P23-09 Premier Bank Drive Through

- Applicant: Brian Midock
- Location: 830 North Court Street

Request: Site Plan and Conditional Zoning Certificate approval for a bank drive through expansion

SITE PLAN - NEW 5/31/2023 1" = 10'-0"

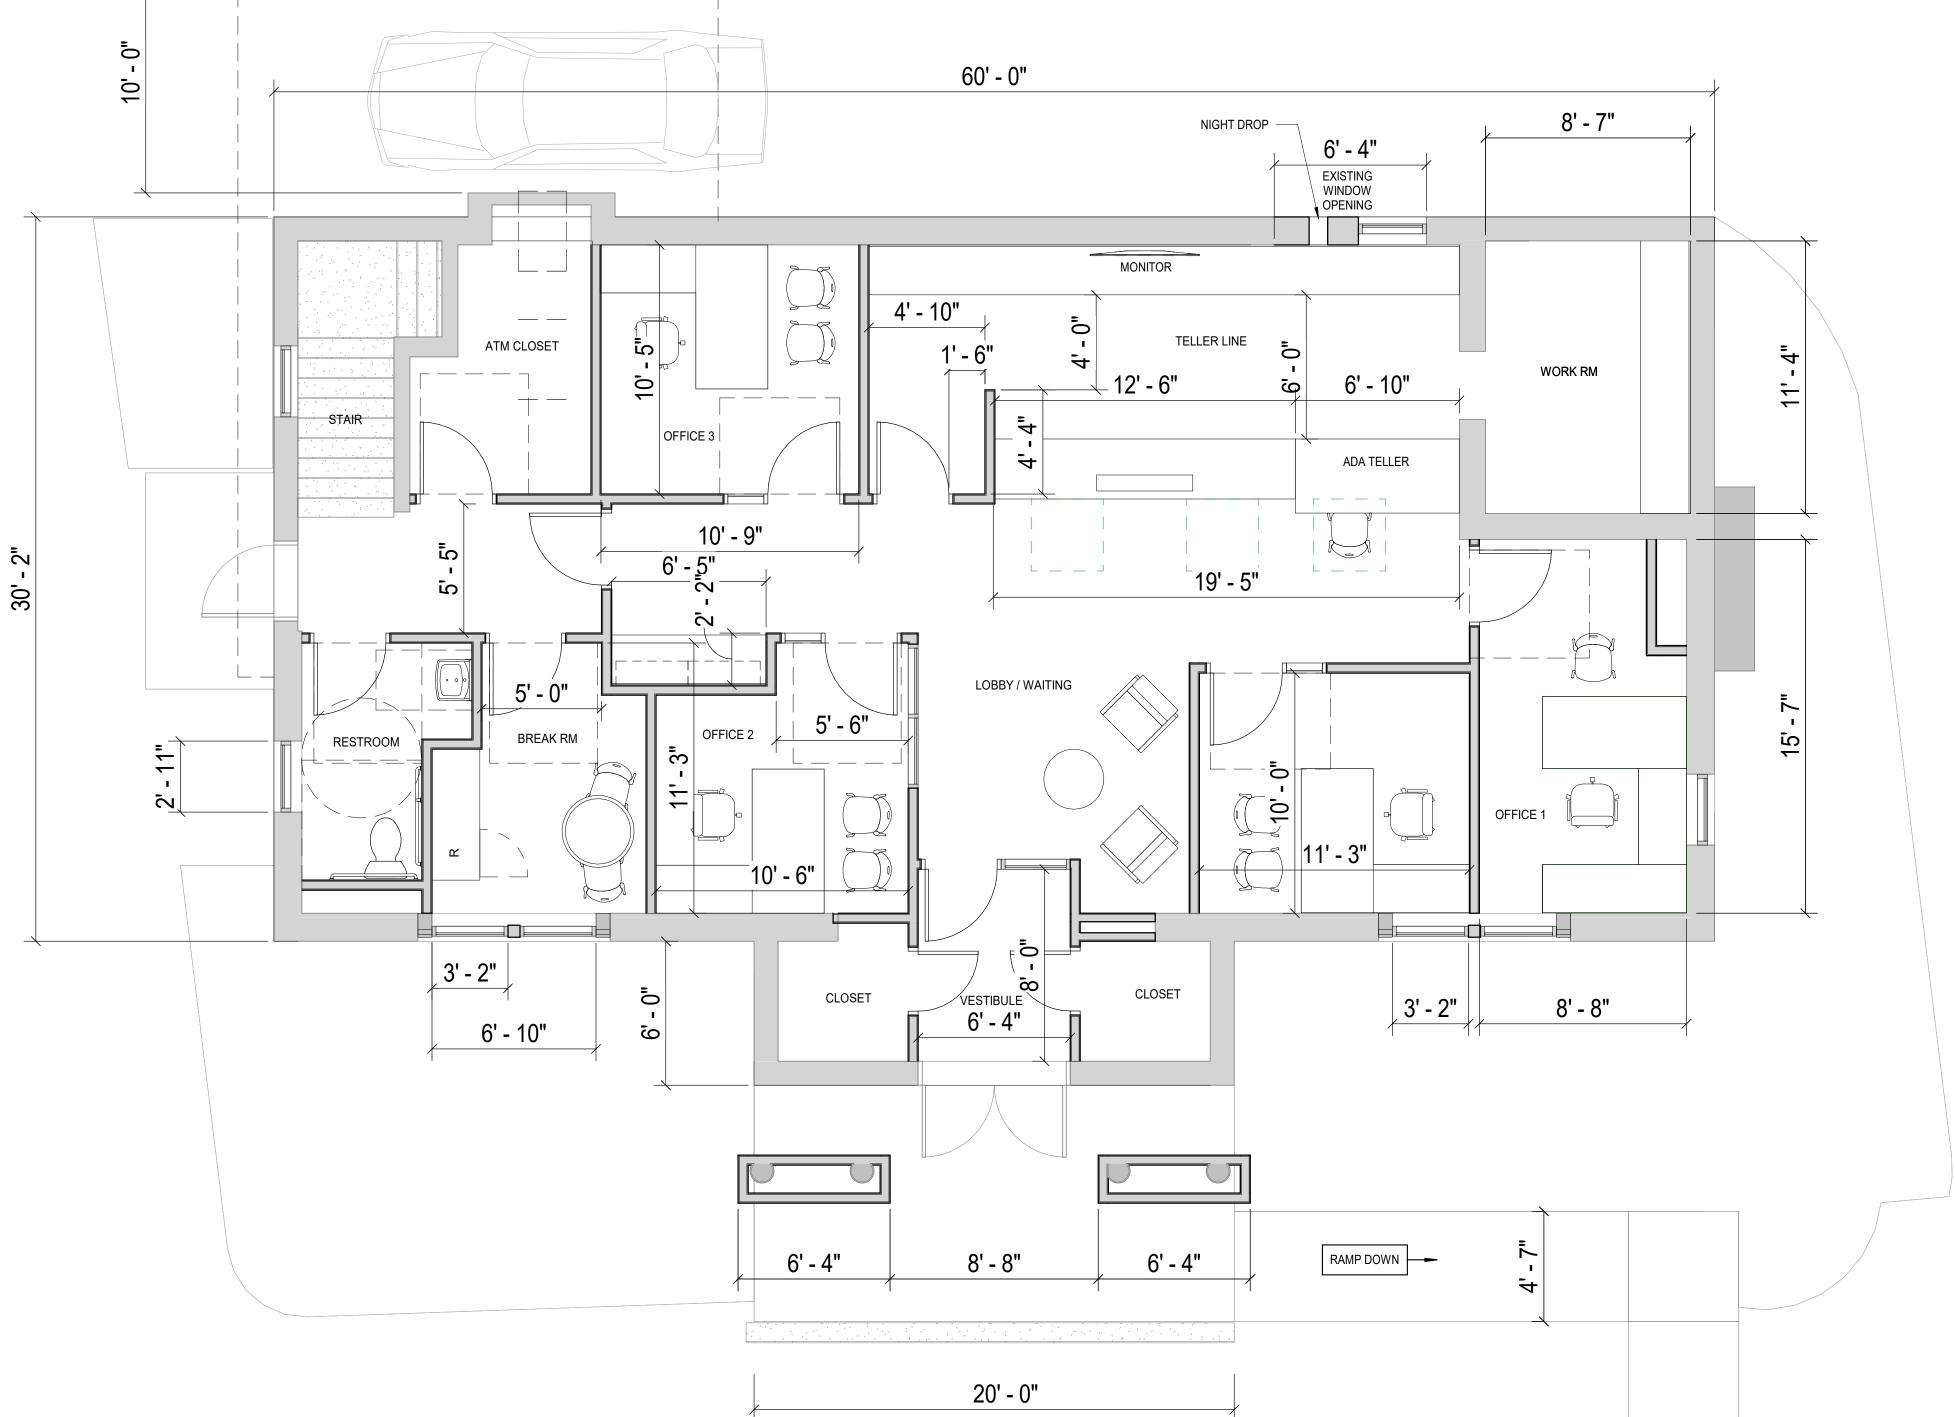
An existing partial ingress/easement is indicated on plans. The Engineering Department has noted that the easement should be extended to allow the property full access.

Parking Lot Landscaping – New grass islands have been created on the east side of the site. The landscape islands must incorporate landscape materials such as trees, bushes, and/or shrubs per Section 1145.09(b). Trees have been added to the new landscaped islands, though the size and species will need to be indicated.

<u>Trash Enclosure</u> – A trash container was previously shown in the northeast corner of the site. The container cannot be situated at the indicated location as a stormwater inlet structure is present and it is within the required setback.

A trash container has been removed from the plans. If a trash container is incorporated, it must contain an enclosure, meet the applicable setback for accessory structures (20 ft.), and cannot be located on or adjacent to a stormwater inlet structure.

- 1. Access easements shall be modified or created as required by the City Engineer.
- 2. The size and species of proposed landscaping shall be indicated.
- 3. If a trash container is located on the site, it must have a compliant enclosure, meet applicable setbacks (20 ft.) from property lines, and cannot be located on or adjacent to a stormwater inlet structure.

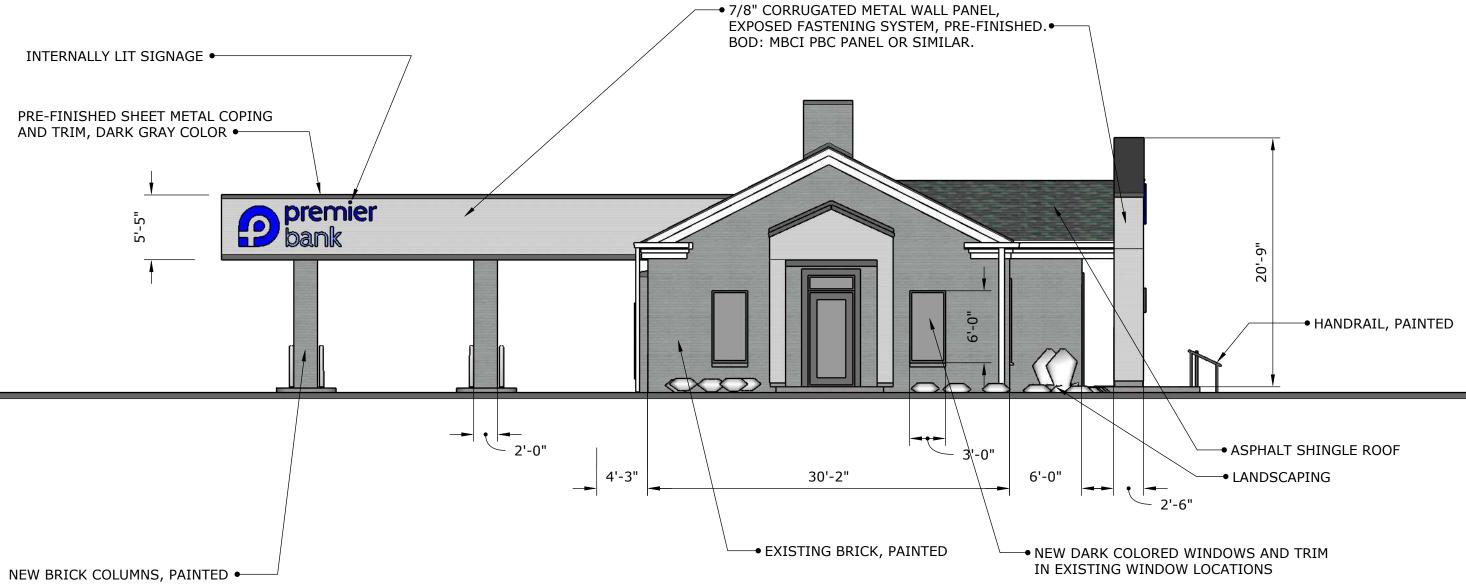
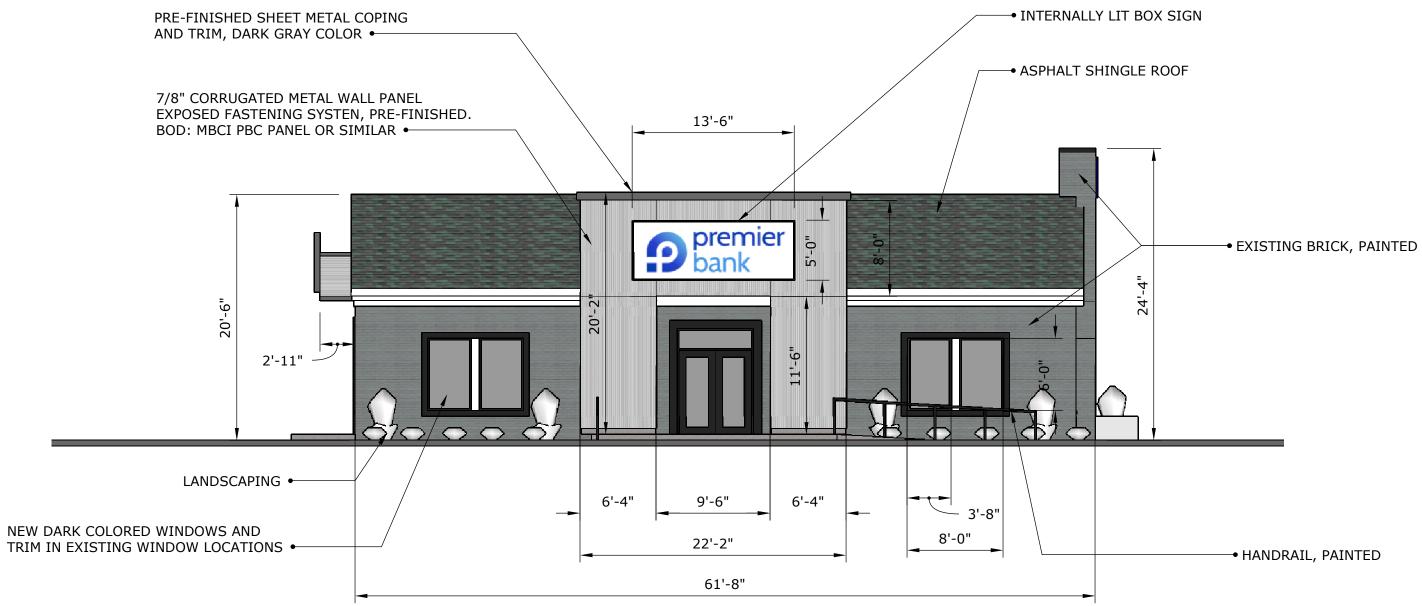
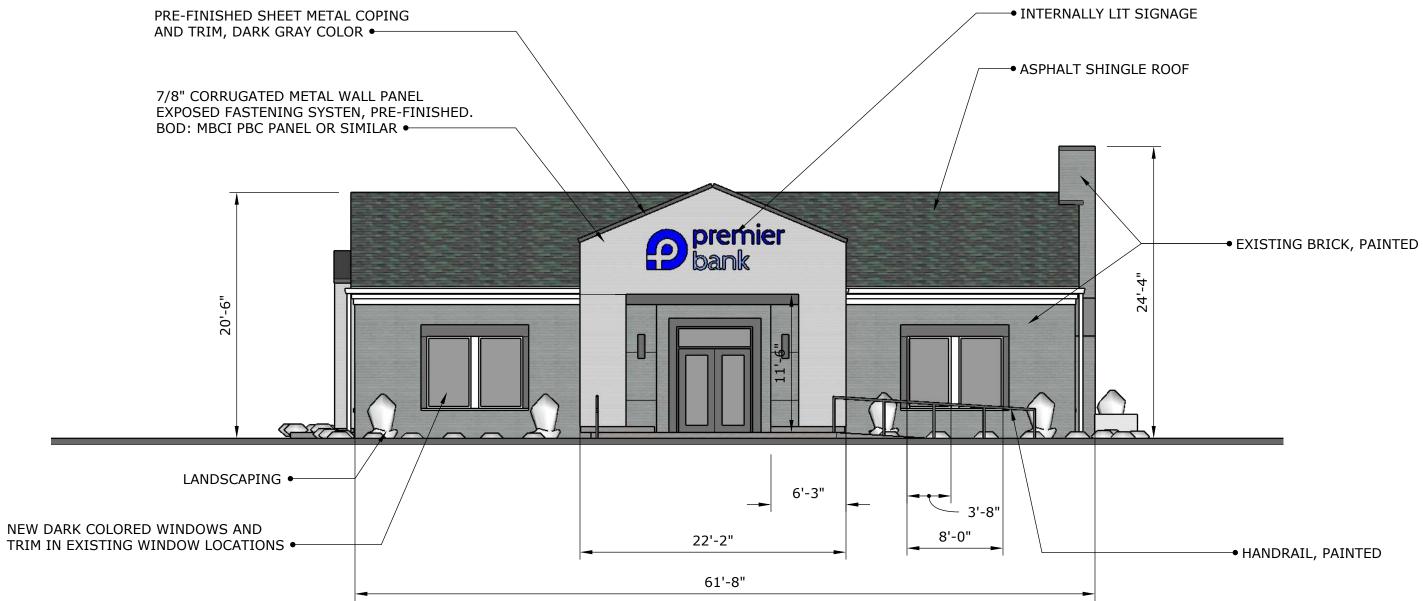
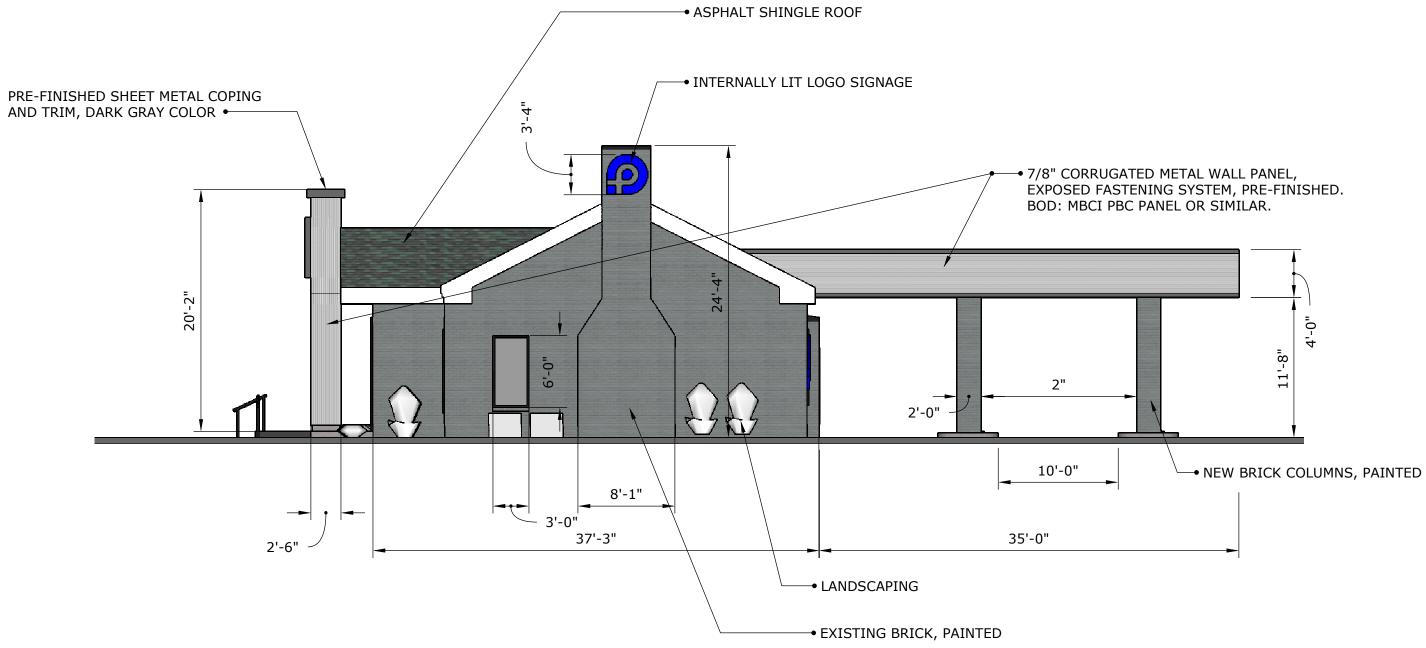
Revised architectural plans incorporate alterations to the building exterior and an addition of a rear canopy:

- The brick on the building is proposed to be painted a gray color.
- Entrances on the front and side of the building currently include pitch roofs with rounded columns. The front entrance will be modified to include a large entry with a pitched roof clad in corrugated metal. The side entrance will be modified to include a small projection with a pitched roof also clad in corrugated metal.
- Windows with white trim will be replaced with dark framed windows.
- A rear canopy will be constructed to cover one row of vehicles. It will also be clad with gray corrugated metal. The canopy has been reduced in width from 24 ft. 8 in. to 20 ft. and does not affect the north building elevation.
